RE: Seattle Asian Art Museum in Volunteer Park

Dear Landmarks Preservation Board Members:

FSOP-Landmarks Board – Seattle Asian Art Museum in Volunteer Park - Comments

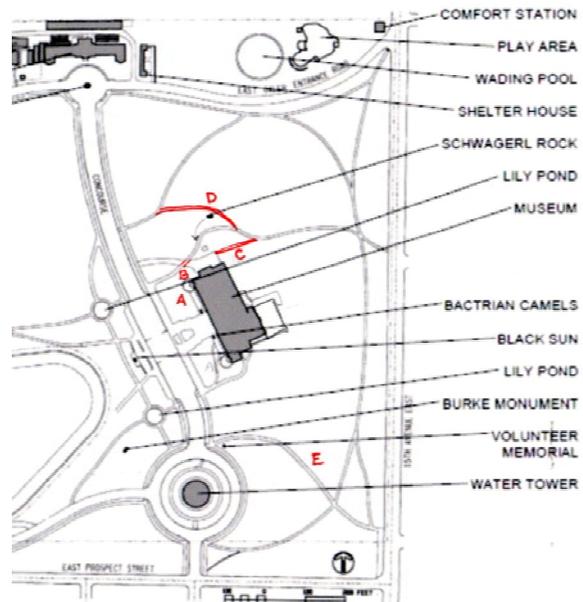
In commenting on the current proposal, the proposed interface of the building expansion to the east with the ground plane is of particular concern. There is an opportunity to reduce the scale of the building by setting it into the existing grade. Identifying a suitable interface of the building with the park needs to be defined from the perspective of how the building resides within the site. The landscape as described in the 1903 Olmsted Brothers report was to be of a “neat and smooth style of landscape gardening throughout, thus harmonizing with its surroundings.”

The museum proposal to further extend its footprint into the park by grading a terrace extension 20-26 feet eastward from the proposed 35-foot addition is contrary to preserving the park landscape. It creates a totally new landscape that is not compatible with the historic character of the east side of the park as a greensward with a gently sloping lawn interspersed with trees and planting. The museum needs an egress door on the lower level, but it does not need a terrace or a floor-to-ceiling bank of windows. Having entertained a range of aspirations for what the addition might provide, we now more clearly recognize that the east side of the building sits in an informal natural landscape compared to the formal character of the highly designed west entry. Therefore, we find programmed space added to the backside of the building to be inconsistent with the historic site. Rather, there should be a more focused examination of the building placement within the existing landscape and how it serves as a backdrop for the park in the least intrusive manner.

As such, the transition to the greensward should begin immediately at the eastern edge of the museum building.

– Current park plan

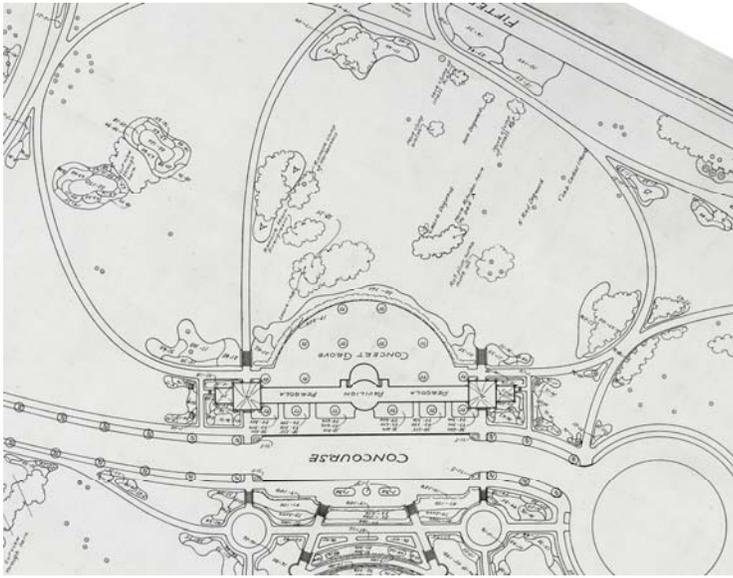
- A. In the lawn in the front (west side) of the museum, the landscape architect proposes to install a new ADA path through the north Hoggson lawn and to reconfigure the existing one in the south lawn to be compliant. We support making the south path compliant, but do not think that inserting a path in the north lawn is appropriate, since it was not part of the Hoggson plan. Inserting intrusions just for the sake of creating symmetry does not meet the intent of Federal Standards. The path on the south side requires less grade change and thus can sit more discreetly in the landscape.

- B. The existing path that connects the north lawn of the museum to the northeast park greensward, is an important connector within the park and provides a typical Olmstedian experience of transitioning between spaces and being able to see through and be drawn to the next space. The upper section of this path is part of the Hoggson plan, which reconnected the original east-west Olmsted path when the museum was built in 1932.

The museum proposal takes over this path as access to the elevated ADA ramp for staff. We believe that both needs can be met, by having the path divide to join the ramp and allow the park path to continue down into the park. Retaining this path is highly desirable.

- C. Reestablishing the east-west Olmsted path is important for continuing access from the east side of the park to the heart of the park in front of the museum. The Hoggson plan was laid out to retain this important east-west connection, but over the years it has, in effect, been blocked by parking and dumpsters.

There is an opportunity to reinstate this historic connection, not as a main ADA path, but as an optional path connection so that park users have a convenient and direct way to get from the east side of the park to the front of the museum. The dumpsters are proposed to be placed out-of-sight behind the loading dock and there is no need for a parking lot to

take up park land when there is plenty of parking elsewhere and nearby in the park. With the reconfigured loading dock area, the path can share the driveway which will have relatively limited use on any given day. Since it won't be a main path it can easily be blocked off when special events are happening that would require exclusive museum use.

- D. The proposed ADA connection north of the museum in the northeast greensward by itself takes park users far out of their way, but in combination with the existing and reinstated path connections described above (B. and C.), it could potentially provide an acceptable ADA route if the grading and landscape impacts are properly addressed in laying out the path. Further analysis of circulation routes in the park needs to be done before implementing this new path connection (see E. below).
- E. Resolving ADA access from the SE corner of the park, where the bus stops are that serve the park and museum, needs more attention. Improving such access and determining how it should go through the park is a critical need in addressing pedestrian and wheelchair access.
